**NEMA Comments on Draft ENERGY STAR® Program Lamp Specification v1.0 Draft 2**

**NEMA Comments on ENERGY STAR® Program Requirements  
Product Specification for Lamps (Light Bulbs)  
Eligibility Criteria Version 1.0, Draft 2**

Page 21, Reliability before 40% life

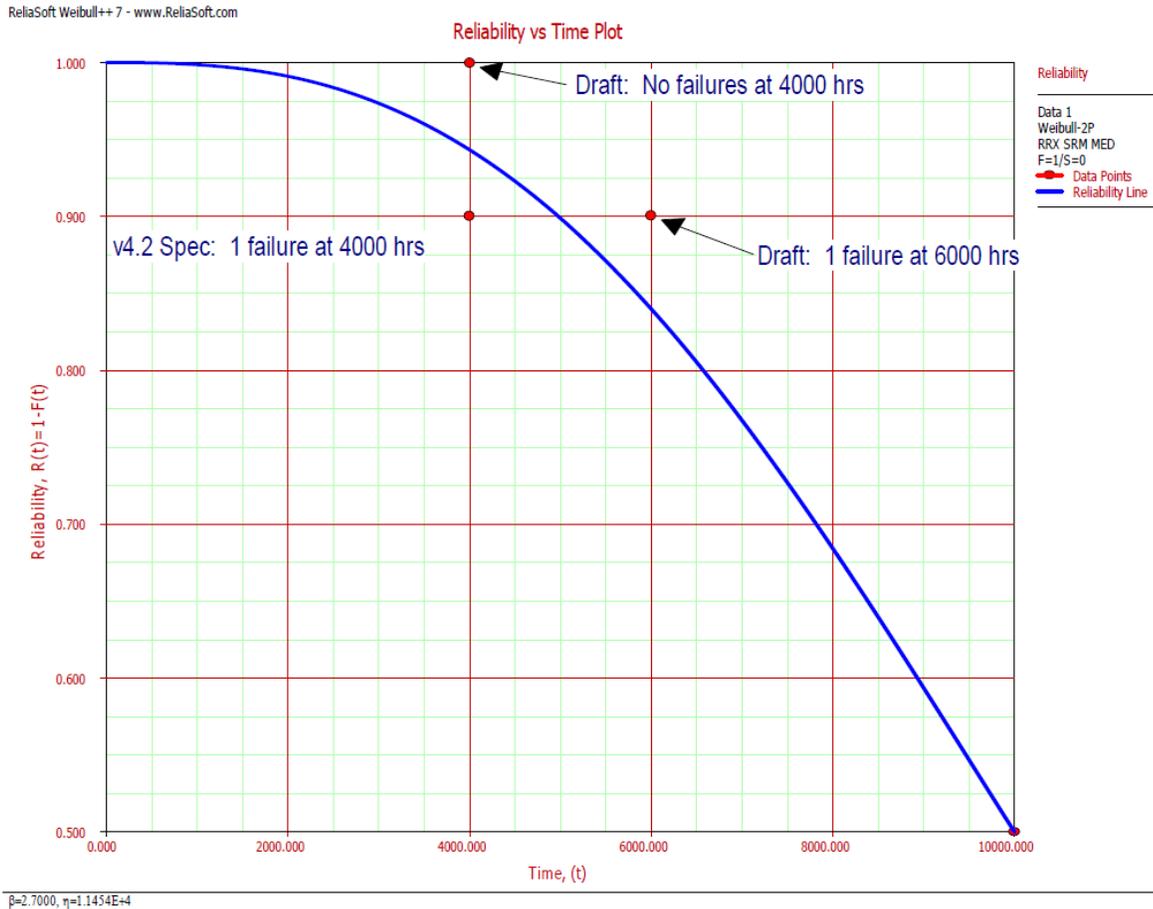
In the draft, ENERGY STAR attempts to define a reliability curve for CFLs with specific reliability targets at 40% of life and 6000 hours. Such a curve is shown in the figure below for CFLs tested under nominal conditions, i.e. 25°C with a B50 life of 10,000 hours. Using this as an example, the figure shows that 6% failures could be expected at 4000 hours. Therefore, it is not realistic and it is unfair to expect zero failures, i.e. 100% reliability, at 4000 hrs. The existing v4.3 specification acknowledges this by allowing at least 1 failure at 4000 hrs for a 10,000 hr lamp. NEMA strongly urges that the CFL reliability requirement be maintained from the ENERGY STAR CFL 4.3 specification.
